- 2. Carl & Emma Clark Estates #2
KPB File 2023-012**

Carl & Emma Clark Estate #2 Preliminary Plat

ITEM 1 - CARL & EMMA CLARK ESTATE #2

STAFF REPORT

VICINITY 1" = 1 mile MAP

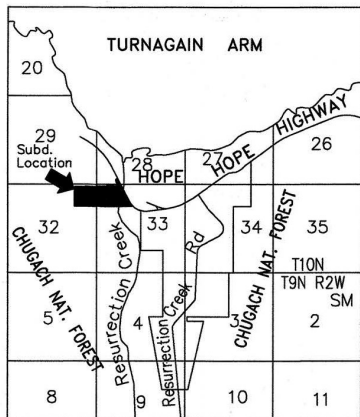
- Staff recommendation:** *Update the location to include portion within Section 29*
- D. A vicinity map, drawn to scale showing location of proposed subdivision, north arrow if different from plat orientation, township and range, section lines, roads, political boundaries, and prominent natural and manmade features, such as shorelines or streams;
Staff recommendation: *Update depiction*

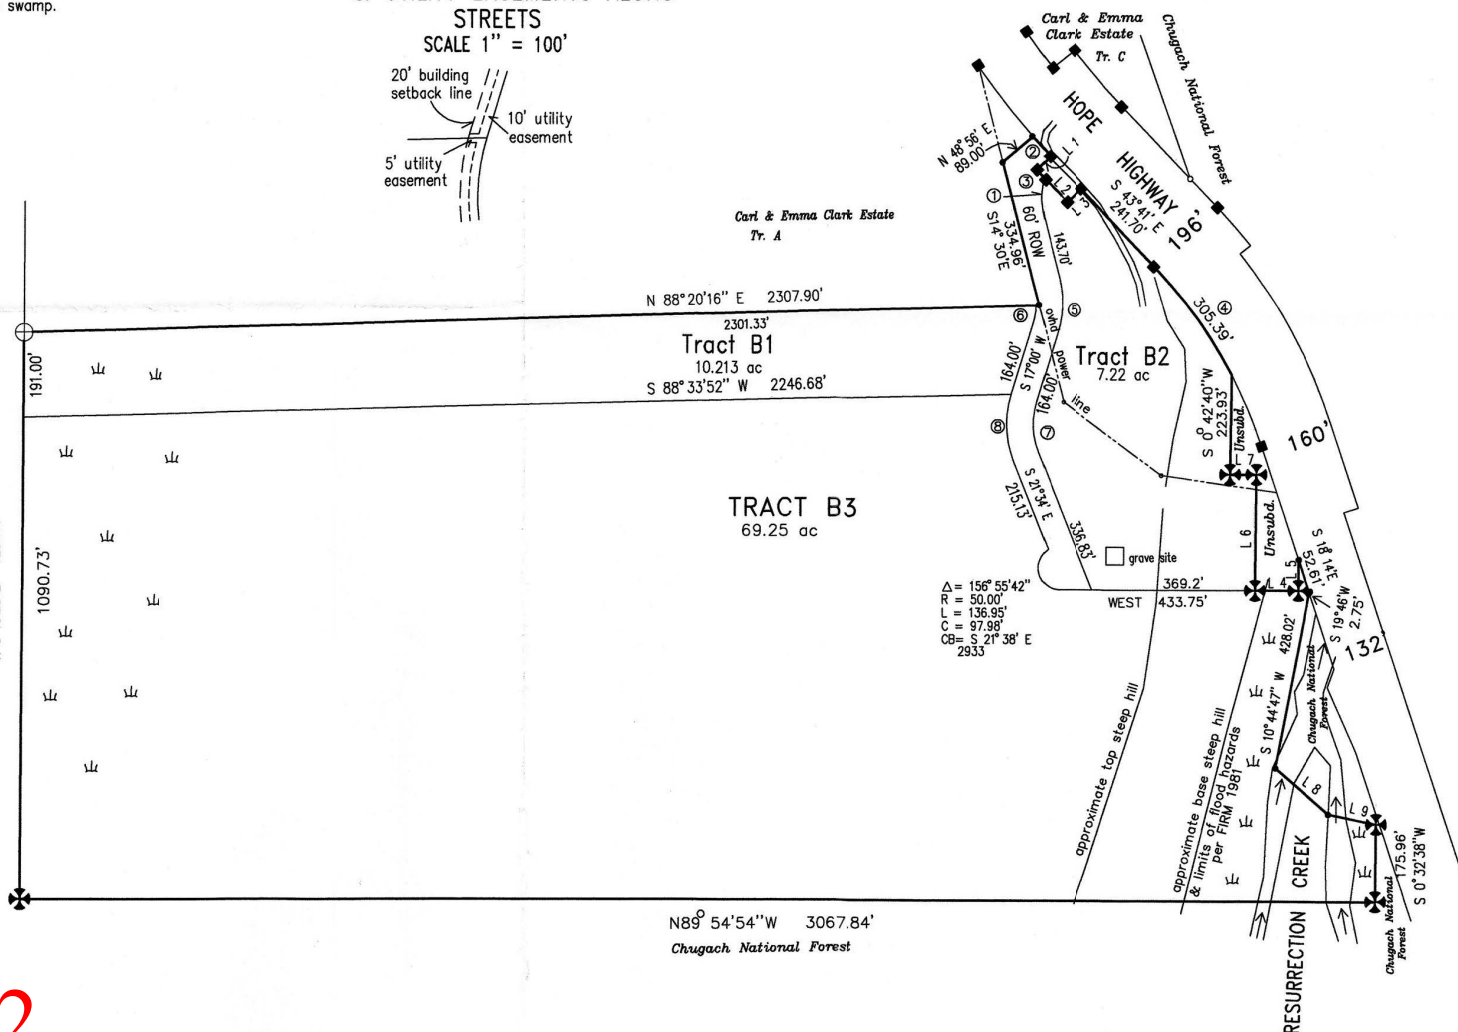
There appears to be some discrepancy on the boundary of the subdivision to the section lines. A Record of Survey was done and recorded, SW 2008-03. Per that record of survey, a portion of Tract B is within the southeast portion of Section 29. ***Staff recommends the surveyor verify the location of the section corner and depict the location in relation to the subdivision, amend the location description in the title block, and update the depiction within the vicinity map.***

is present. **Staff recommends** additional wetland information be provided on the final plat.

Contour information is not available for this area. Looking at KPB GIS imagery there does appear to be some areas to the west with some steep areas as well as near Resurrection Creek. The surveyor does state the terrain slopes towards the west with some areas being around 15% grade. The hill depicted near Resurrection Creek contains some slopes over 25% grade. The right-of-way dedication is free of steep slopes. **Staff recommends the steep hill remain depicted on the final plat and if any other steep areas are detected during the field survey they be indicated on the final if it does not conflict with other required data.**

Proposed Tract B2 will contain multiple improvements. **Staff recommends the surveyor verify no encroachments will be created by the placement of the lot line.** A private grave site is present within proposed Tract B2. If this is the site referenced within an easement located within a deed, **staff recommends the depiction remain with a reference to a plat note with the easement information.**

Resurrection Creek runs adjacent and within the southwestern portion of the subdivision. A plat note is present on the plat regarding the Anadromous Waters but should be revised to match code.

There is a recorded easement for the benefit of Chugach Electric Association, Inc. The easement does not have a disclosed location. **Staff recommends a plat note be added for the easement.**

- F. The location, width and name of existing and platted streets and public ways, railroad rights-of-way, easements, and travel ways existing and proposed, within the subdivision;
Staff recommendation: *An approved street name will be required.*

Platting Staff Comments: *The plat note present should be updated to match the wording within code.*

Platting Staff Comments: A soils report is not required due to the size of the lots. Correct the typo within the note.

Plat Note 6 could be removed as it is discussed under the flood hazard notice located on the plat.
Plat note 7 should be reworded to match KPB Code.

Staff Discussion: Tract B1 is proposed to be a 10.213 acre lot that has an average width of 200 feet and average depth of 2,265 feet. This is a ratio of 11.3:1. There will be a 200 foot frontage along the new dedication. Per KPB findings the property is not subject to a section line easement. If it is determined that the property is subject to one

Staff reviewed the exception request and recommends **denial** based on findings 1,2, 6, 7, and 9.
